PCN (Product Change Notice)

PCN Number: PCN_SwTASV_20260929 Affected Series: WS-TASV Affected Part Number: see table "PART NUMBER, REVISION & DATASHEET" PCN Date: 2026-06-29 (YYYY-MM-DD) Effective Date: 2026-09-29 (YYYY-MM-DD)	Change Category: ☐ Equipment/Location ☒ General Data ☐ Material ☐ Process ☐ Product Design ☒ Shipping/Packaging ☐ Supplier ☐ Software
Contact: Product Management Phone: +49 (0) 7942 - 945 5001 Fax: +49 (0) 7942 - 945 5179 E-Mail: pcn.eican@we-online.com	Datasheet Change: ☒ Yes ☐ No Attachment: ☐ Yes ☒ No

Due to packaging optimizations, Würth Elektronik eiSos will adjust the reel size, update the SPQ accordingly, add the outer carton size and quantity, and correct the typo.

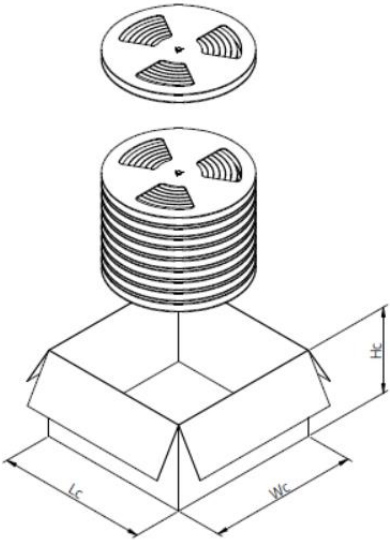
1. adjust Reel Size : 430133050816:

before change	after change
SPQ Qty./ Reel	1500	2000
Reel size	13" (330 mm)	15" (380 mm)
Outer carton Qty.	15000	20000
